Subject: MHI's Responses to US-APWR DCD RAI No. 459-3331

Responses to Request for Additional Information No. 459-3331,
Revision 1

RAI NO.: NO. 459-3331 REVISION 1
SRP SECTION: 03.06.02 – Determination of Rupture Locations and Dynamic Effects Associated with the Postulated Rupture of Piping
APPLICATION SECTION: 3.6.2
DATE OF RAI ISSUE: 09/16/2009

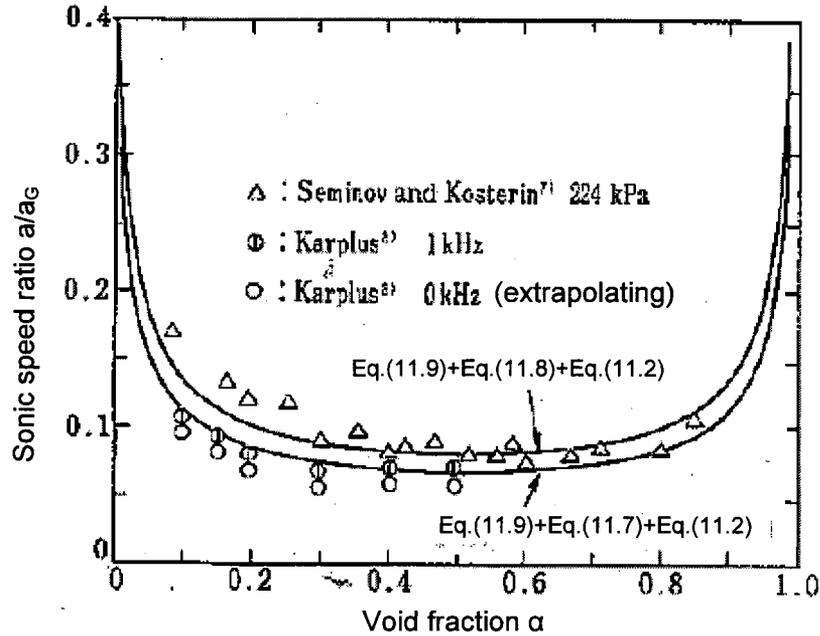
(e) There does not appear to be any consideration of how potential feedback between the jet and any nearby reflecting surface(s), which can increase substantially the dynamic jet forces impinging on the nearby target component and the dynamic thrust blowdown forces on the ruptured pipe through resonance, is considered. Provide details (with example, if available) that describe the methods including a description of how feedback amplification of dynamic blowdown forces will be considered for calculating the blowdown forcing functions at break locations and identify the computer program that will be used, if any.

The sonic speed of air-liquid two phase flow is decreased because the sonic wave is reflected by droplets as shown in the figure below. This decrease of sonic speed varies with droplet density, and the sonic speed itself has a distribution in the jet. Then the resonance phenomena itself does not occur because the frequency of pressure wave propagation changes by location. Therefore, the feedback of dynamic blowdown forces does not occur and amplification of feedback of dynamic blowdown forces does not have to be considered for calculating the blowdown forcing functions at break locations.

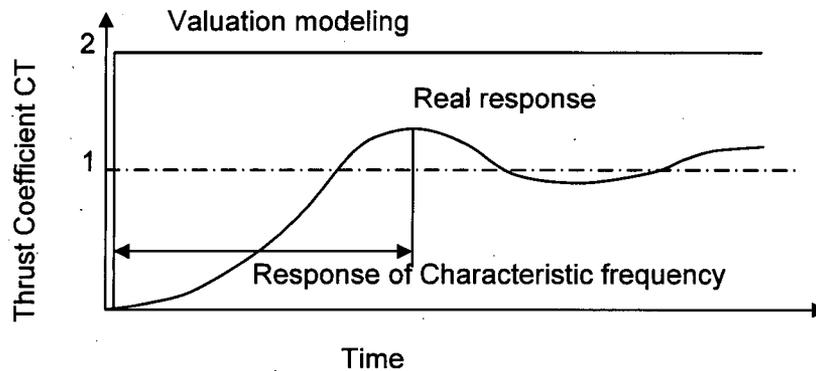
In its response to RAI 03.06.02-10, MHI stated that the loading time duration of a blast wave on a structure neighboring a pipe break would be negligibly small (less than 1/400th of a second), so that the impulse load acting on the structure (computed by integrating the product of the force and application time) would be negligible compared with loads induced by a jet impingement. However, based on the information in the Knowledge Base for Emergency Core Cooling System Recirculation Reliability, February 1996, Issued by the NEA/CSNI, <http://www.nea.fr/html/nsd/docs/1995/csnir1995-11.pdf>, and ACRS concerns [Wallis - ADAMS ML050830344, Ransom – ADAMS ML 050830341], all high pressure and temperature pipes should be considered as sources of blast waves with initial energy and mass roughly equal to the exposed volume from a hypothesized break. The subsequent damage from such waves has been well documented and is not properly accounted for in ANS 58.2 by the isolated analysis of a pure spherically expanding wave. MHI should provide a rigorous and thorough explanation of their procedures for estimating the effects of blast waves on nearby SSCs. Also, the staff points out that blast wave load analyses should be based on three dimensional (or asymmetric) unsteady analysis of the flow field, with appropriate representation of the surrounding structures, subsequent to the initial blast. MHI is requested to document their blast wave assessment approach(es) in a revised version of the DCD.

The propagation of shock wave is affected by the surrounding sonic speed. The sonic speed at the end of the propagating shock wave is one of air, because downstream of the shock wave is air. It is possible that the blast wave force is evaluated using the pressure difference between the shock wave back and forward, and the velocity of the shock wave. Also, the property of shock wave can be evaluated using the pressure ratio of pipe break opening mouth to atmosphere and initial energy of pipe break opening mouth.

This progressive velocity of the shock wave seems to be greater than sonic speed of the air and the passing time duration of shock wave on a structure is extremely short. Even if the Mach number of shock wave is equal to 1.0, the passing time duration of shock wave on a barrier structure having thickness of 1 m (3.28 ft) is about $1/350^{\text{th}}$ of a second. Therefore, as for the barrier structure having natural frequency of less than 50Hz, the passing time duration of shock wave on the barrier structure is a split second.

The force on the barrier structure subjected to blast wave is as shown in the figure below. The response of the barrier structure can not follow the shock wave because the shock wave passes the barrier structure in a split second. The force on the barrier structure subjected to blast wave is less than twice of the static force generated by shock wave. Therefore, the MHI method is conservative even if dynamic response is considered.
